**ADDENDUM NO. 3**

**PROJECT: 5524**  
**February 5, 2024**

**BAKERSFIELD CITY SCHOOL DISTRICT  
MUNSEY ELEMENTARY SCHOOL  
HVAC REPLACEMENT  
3801 BRAVE AVENUE  
BAKERSFIELD, CA 93309**

**DSA APP# 03-122489**

Sheet No.:  
**A6.10**  
Release: ADDENDUM 3

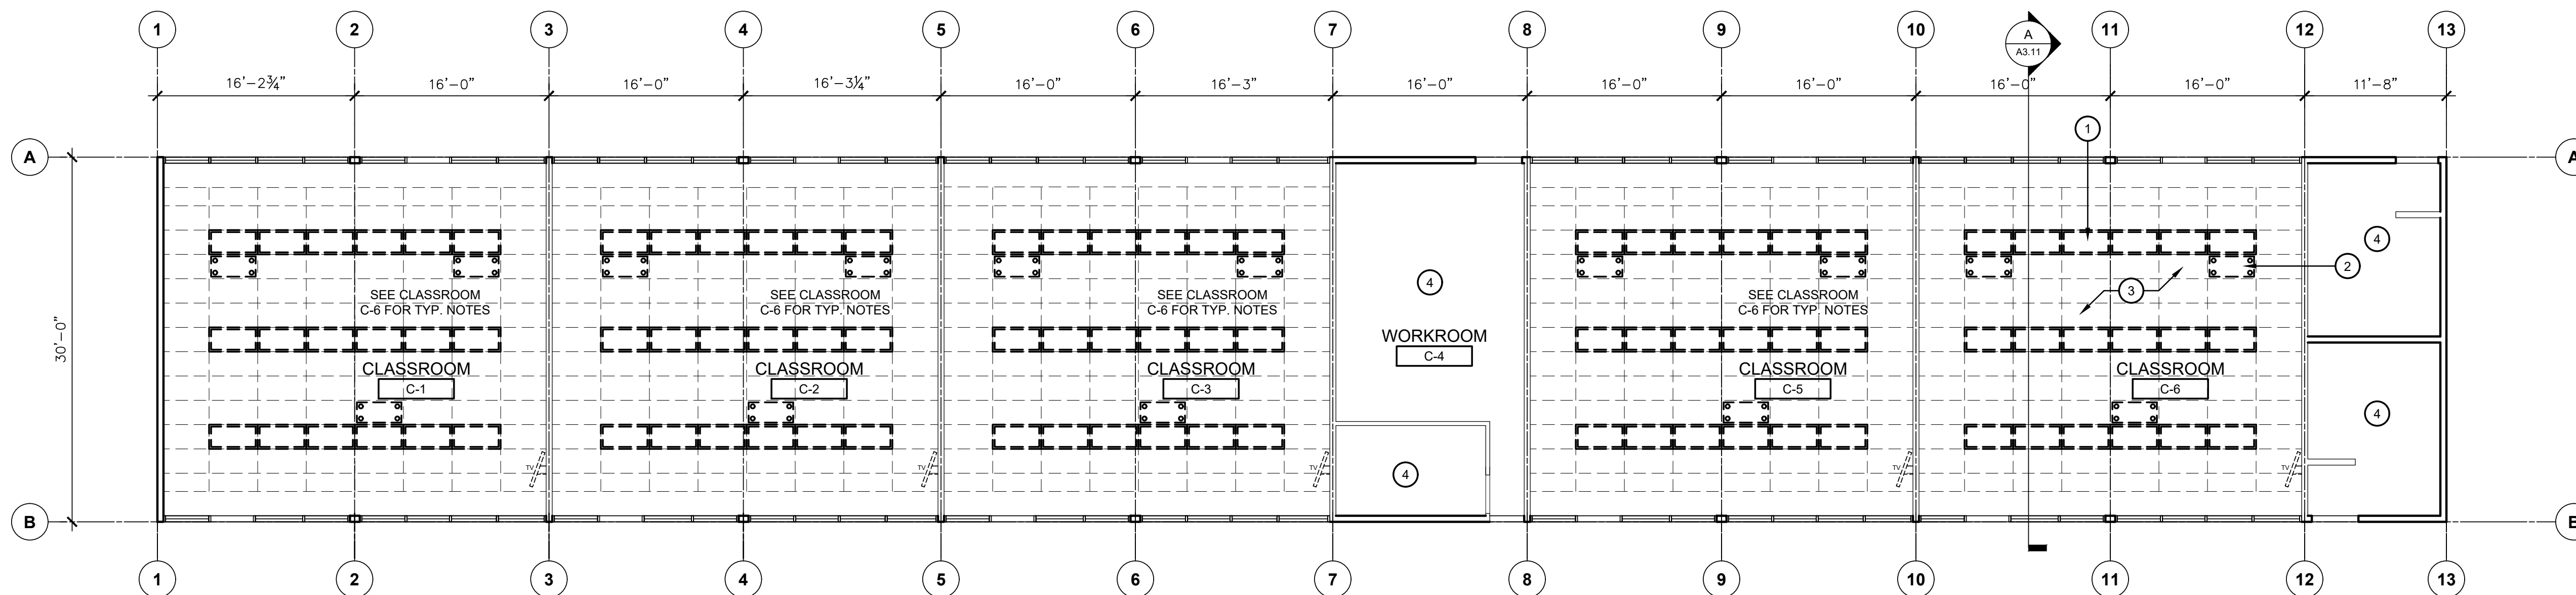
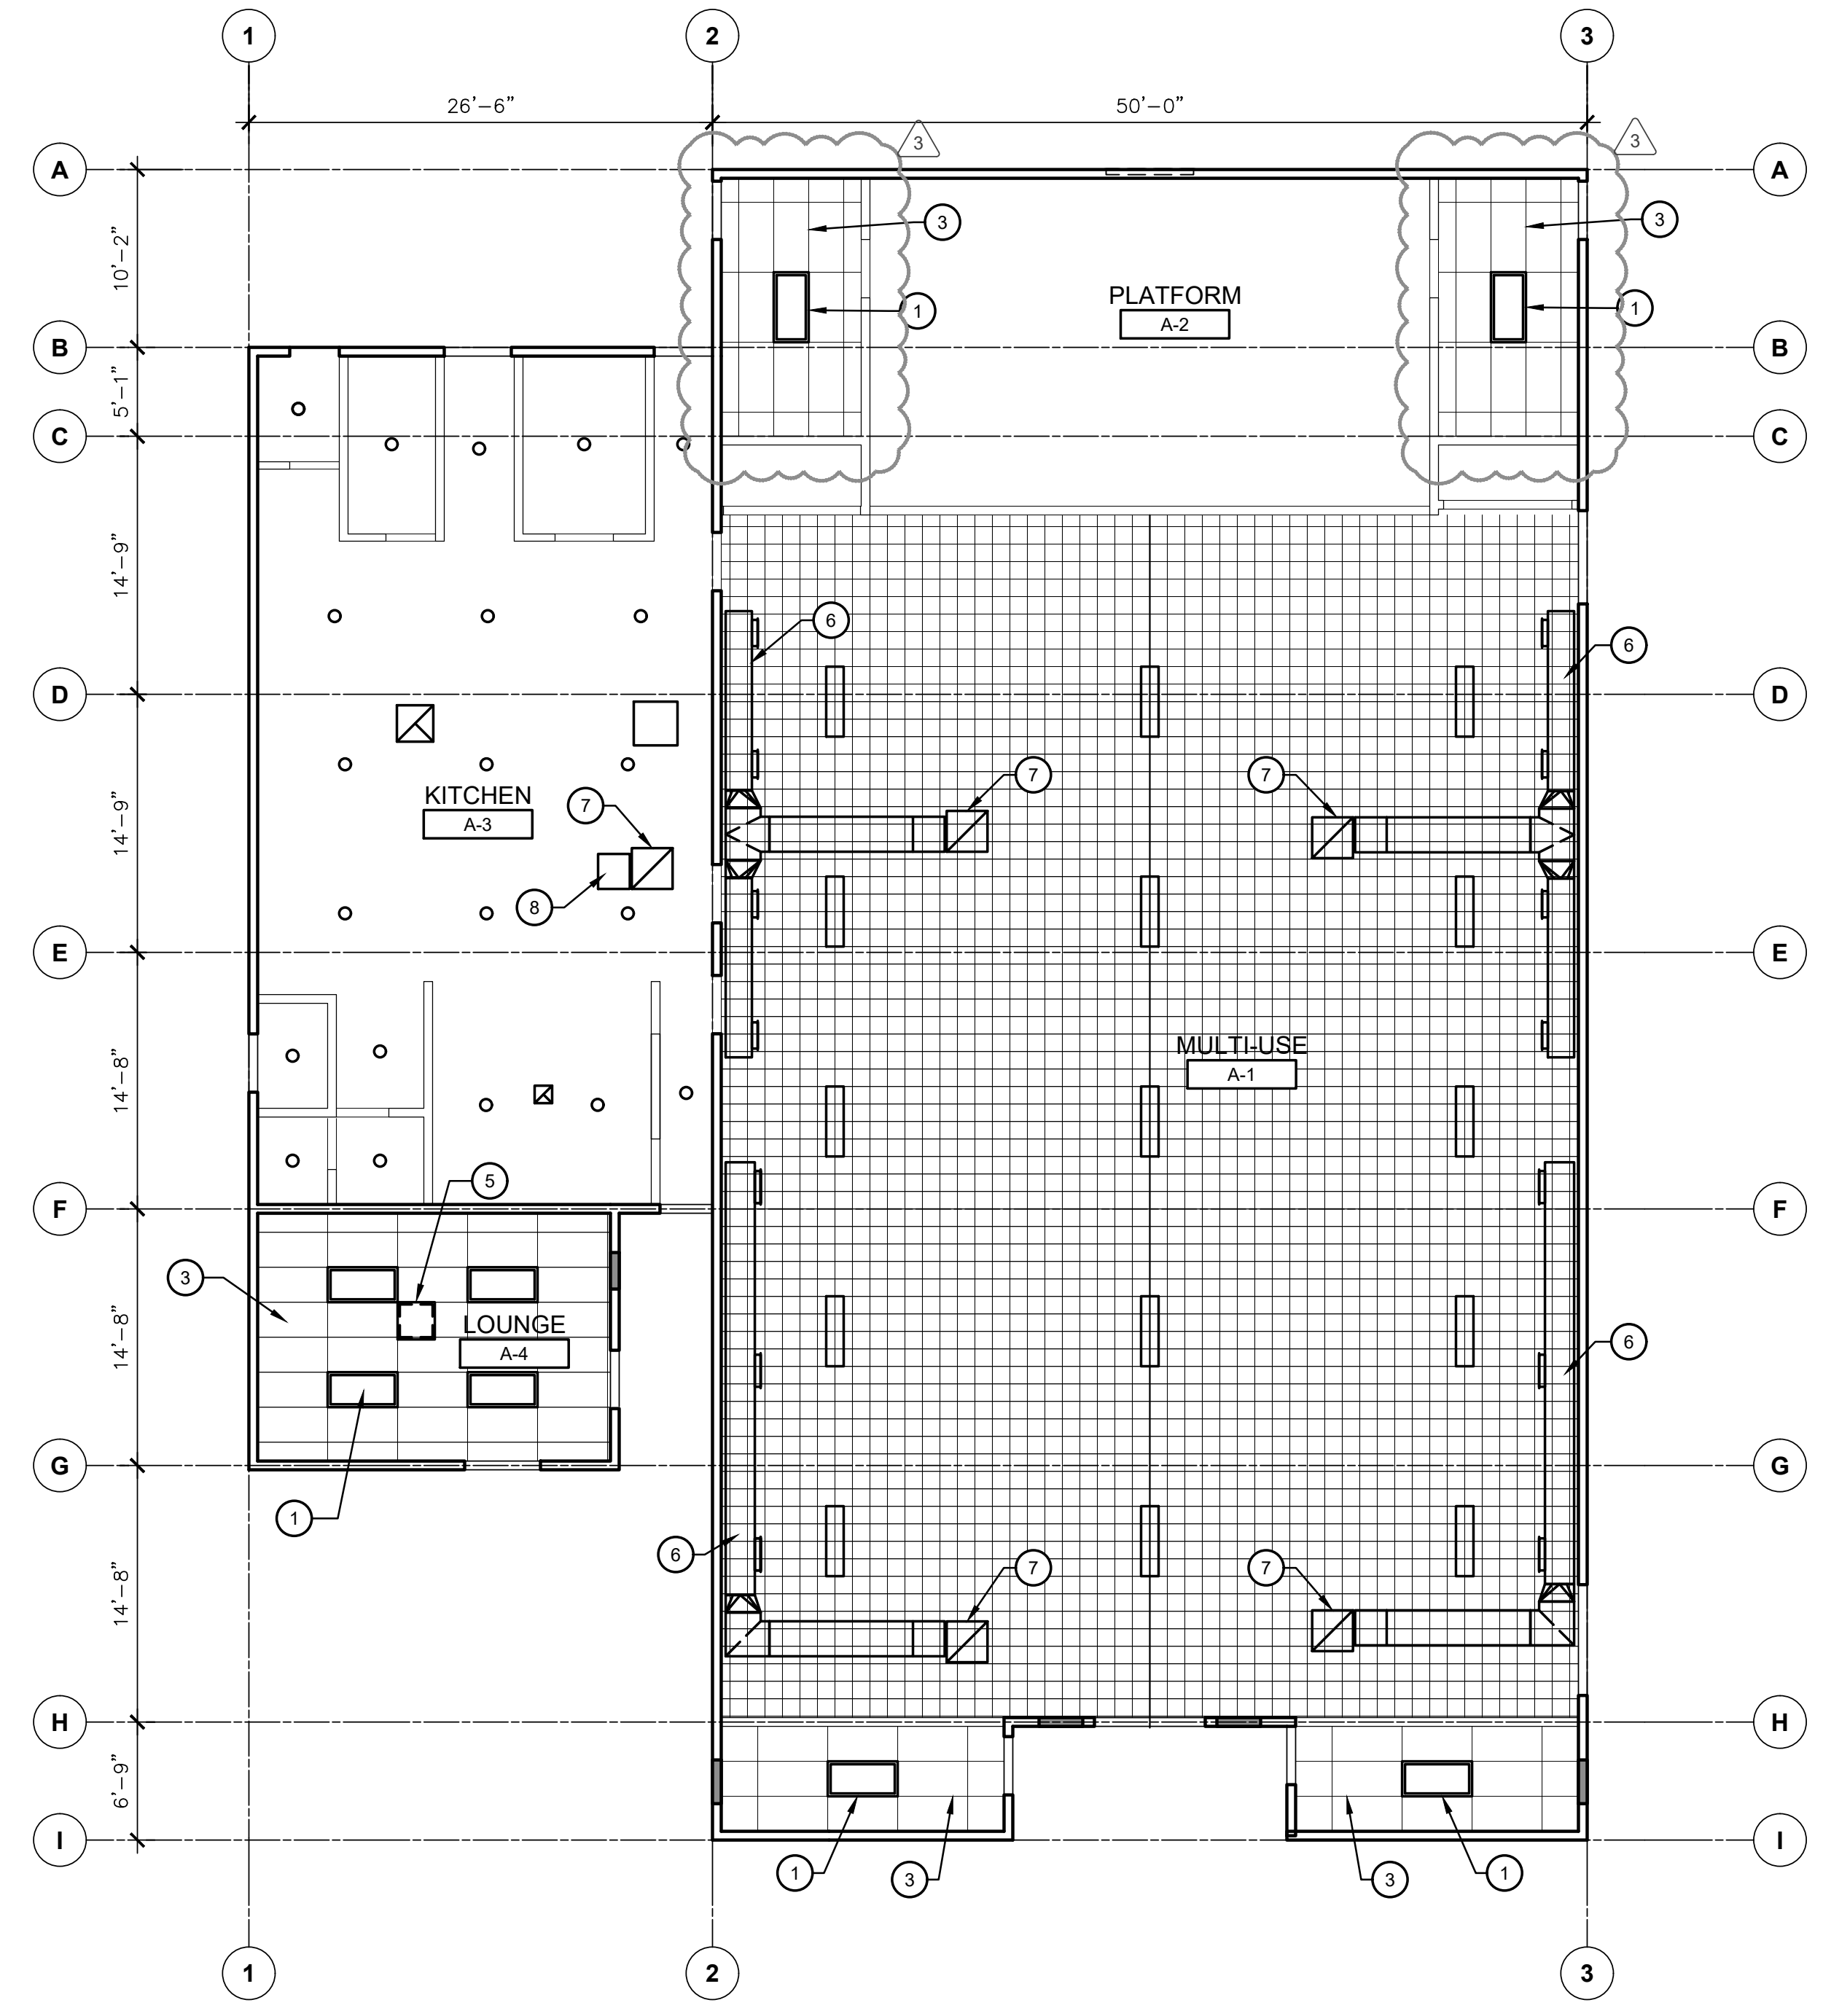
3.10 Building A reflected ceiling plans on sheets A6.10 and A6.20 have been revised to indicate the removal of the existing ceiling in the rooms on each side of the Stage room A-2 and new 2'X4' suspended acoustical tile ceiling system. Building A lighting plan E2.20 was coordinated with the architectural drawings.

Sheet No.:  
**M2.31**

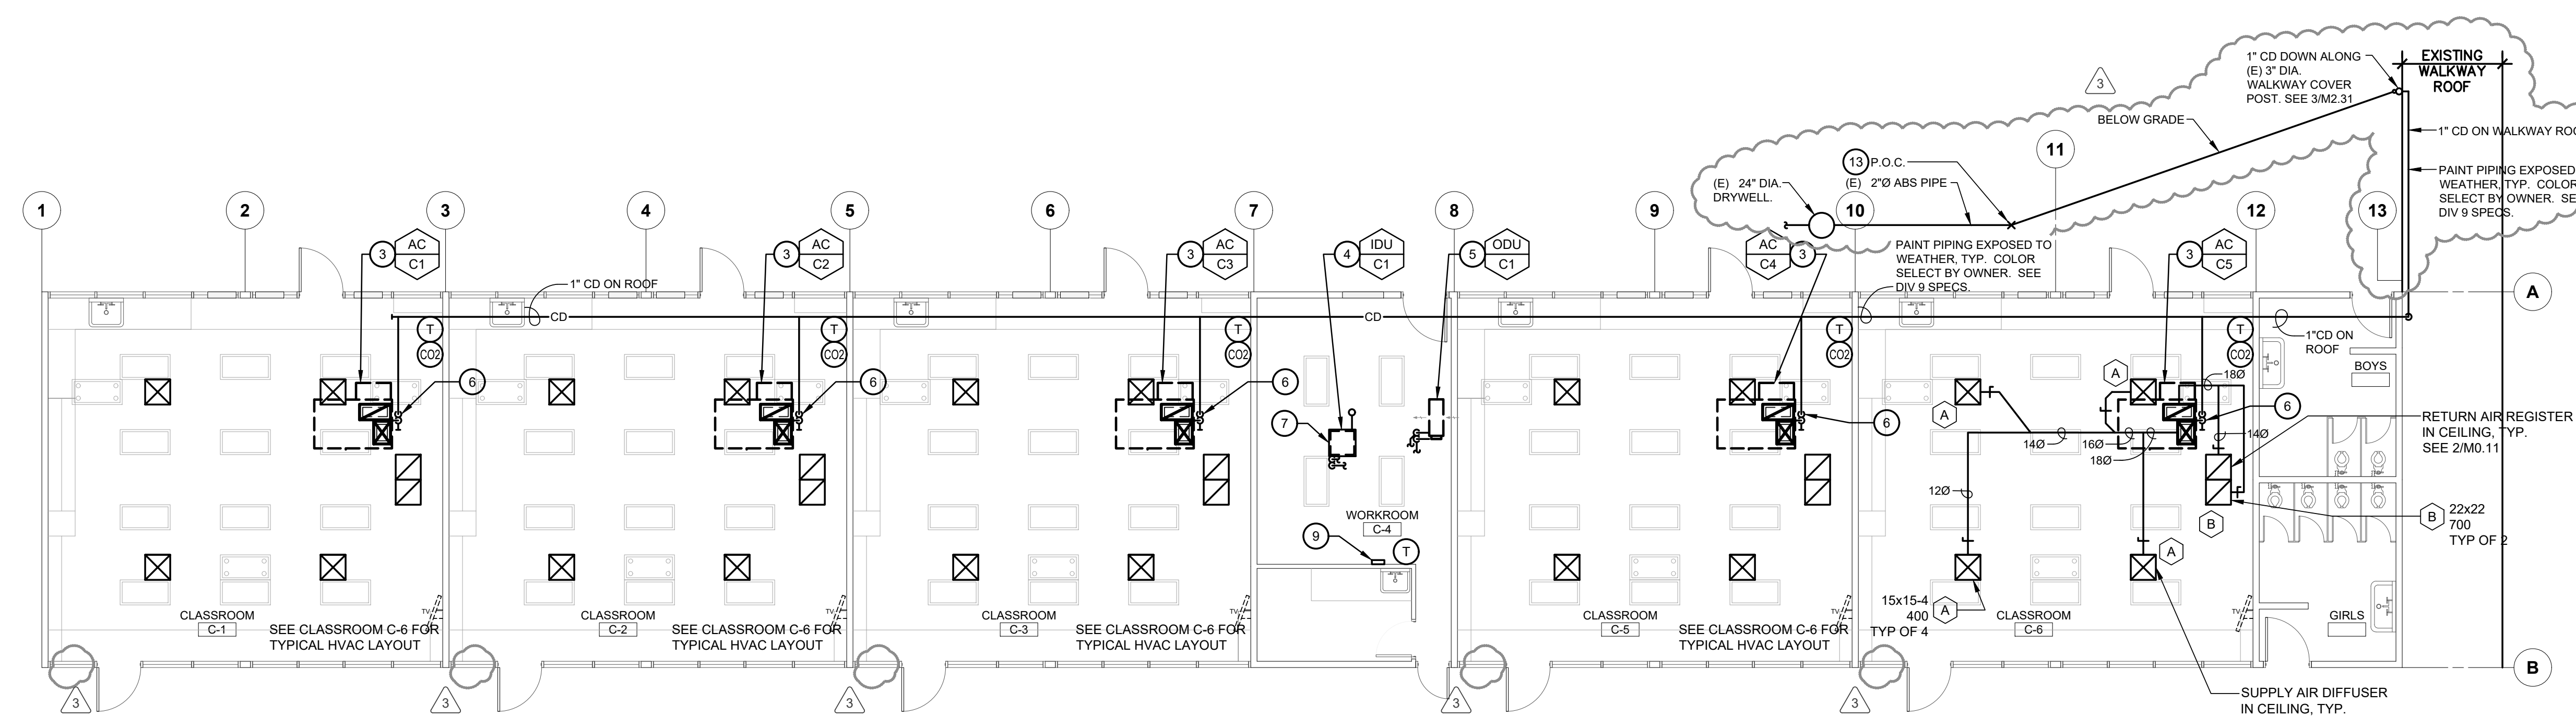
- 3.03 Mechanical sheets M2.31, M2.41, and M2.51. have been revised to indicate continuation of the condensate pipe from the roof to existing drywell.
- 3.04 Each worker on site is required to obtain Two Hour Asbestos Awareness Training or provide proof of training within the last year. Two-hour Asbestos Awareness Training is an annual training.

- 3.05 Remove existing radiator as indicated in revised sheets M2.31, M2.41, and M2.51. After the radiator is removed, the area is to be furred out to accept new tackboard finish. District would like to add new tackboard finish to the walls as highlighted on the attached sketch. Chatfield Clark Ceres Fog <https://chatfieldclarke.com/koroseal-ceres/fog-b321-91/>

- 3.06 Remove existing barometric relief vent and metal panel infill and infill opening as per detail 2/A2.10, also see revised sheets M2.31, M2.41, and M2.51.
